201.1.2.1 PROFILE FOR BRIDGE ALTERNATIVE

201.2.1.1.a PLAN VIEW

Figure 201-3

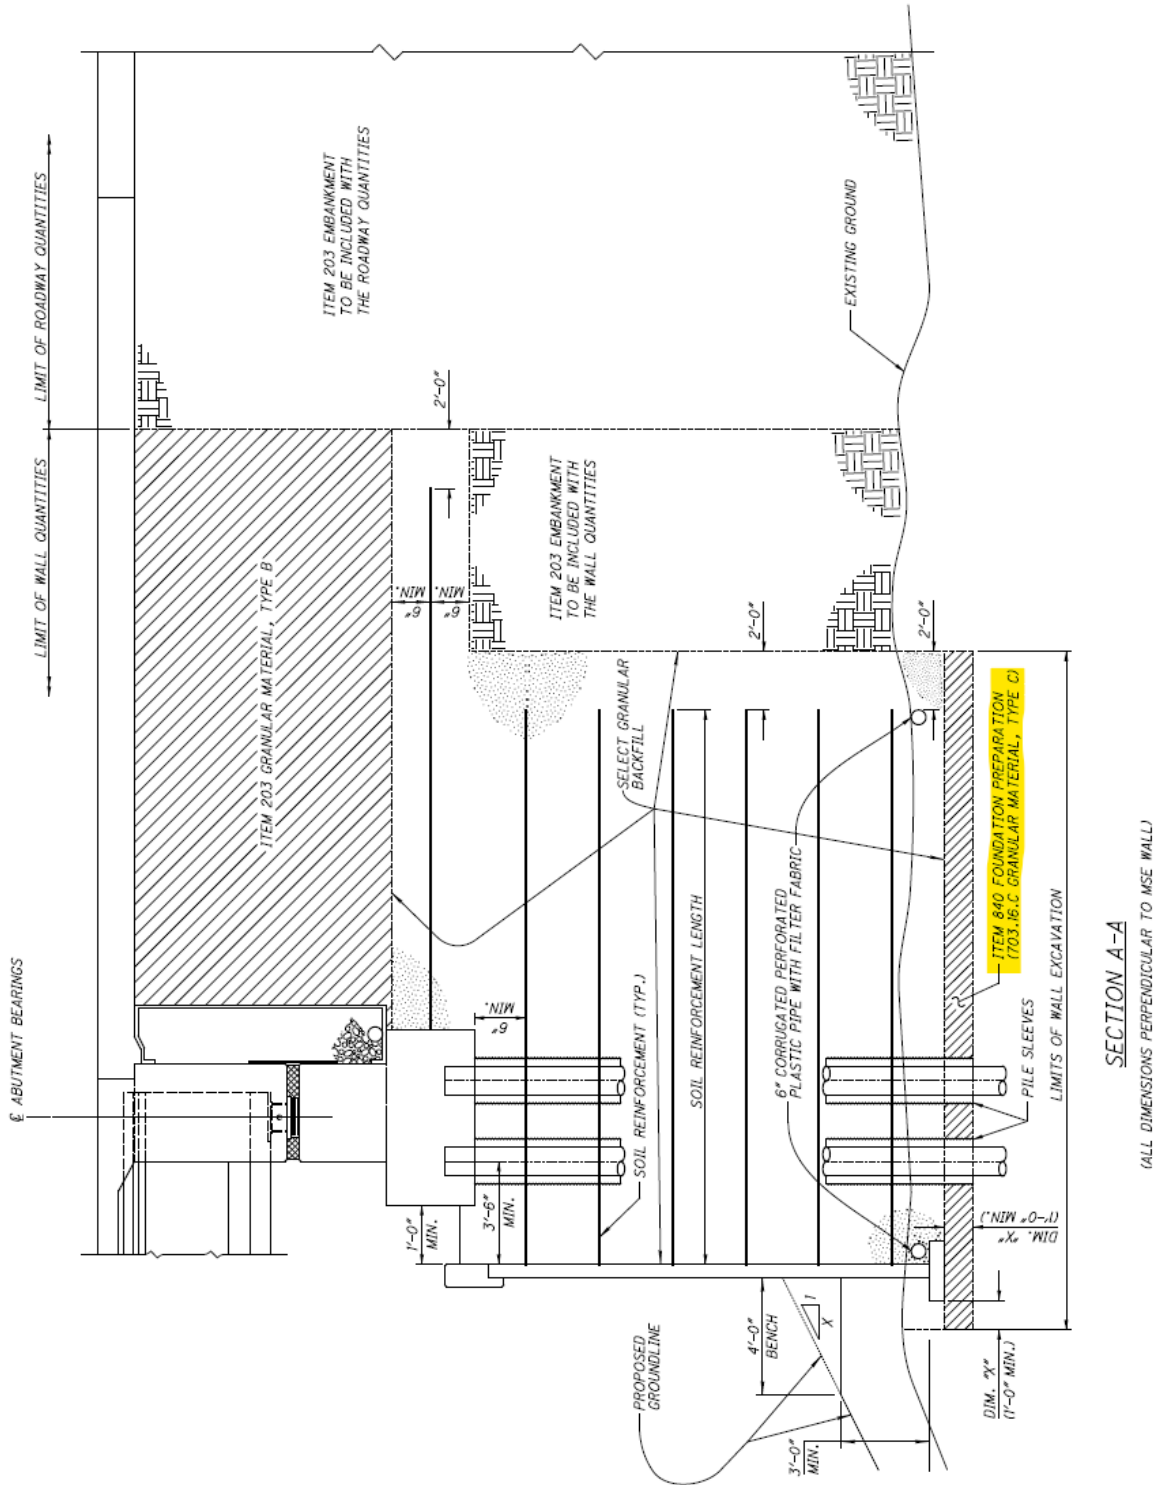
F. Treatment of slopes around the ends and under the bridge (location and length of rock channel protection). Location and width of wildlife path(s), if applicable.

Figure 404-6

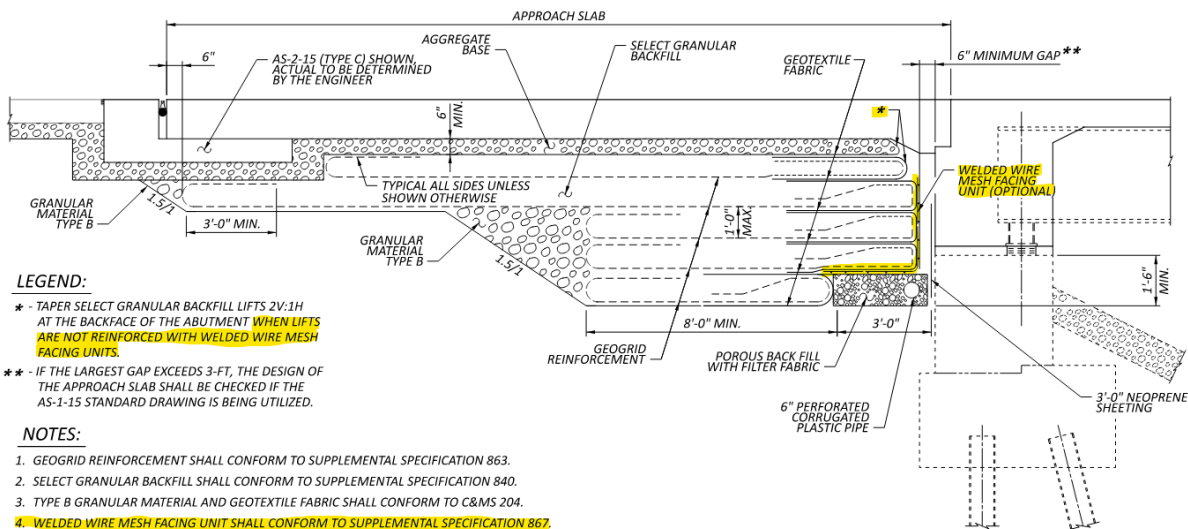
404.6 SEMI-INTEGRAL ABUTMENT CONVERSIONS
